August 15, 2016
PERMIT MODIFICATION APPROVAL
Horizontal 6A / Horizontal 6A Well - 1

Re: Permit Modification Approval for LARRY 3U
47-095-02334-00-00

Extend Lateral

FILE NO. _____
 DRAWING NO. 1
 SCALE 1" = 2000'
 MINIMUM DEGREE OF ACCURACY 1 in 200
 PROVEN SOURCE OF ELEVATION GPS
submeter unit

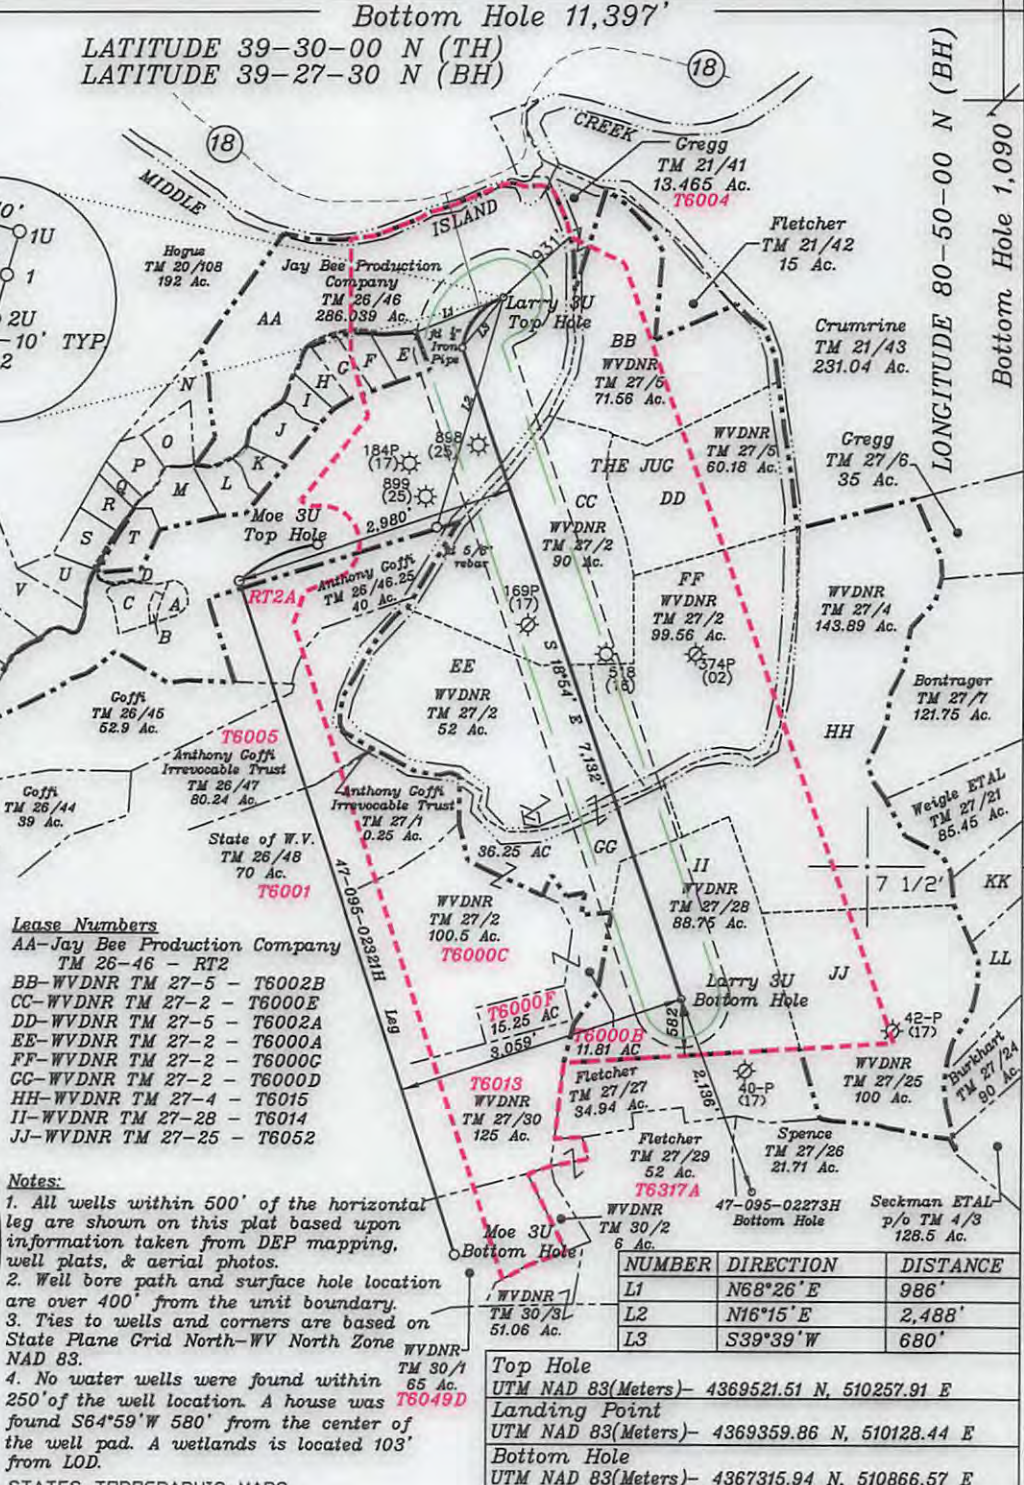
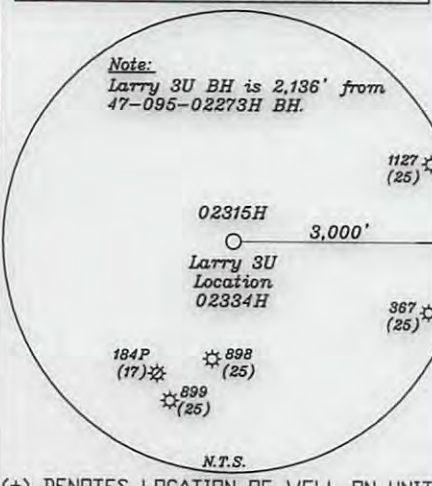
I sent an updated plat on 6-14-2016 for one of our wells we will be drilling. I wanted to find out what the turnaround time is on approval of this modification? 47-095-02334 API. I just want to make sure I have the approved modification before we drill. Thank you for your review! Hope all is well down there!

All applications and mods to extend laterals will now need to include an Area of Review before we can issue. I know you are hoping to get the Larry 3U modification approved but I cannot issue it until we receive the information necessary to meet the rule change.

Looks like Cindy reviewed and approved the updated plat on 6/30. I will track it down to issue the modification and let you know as soon as it is issued.
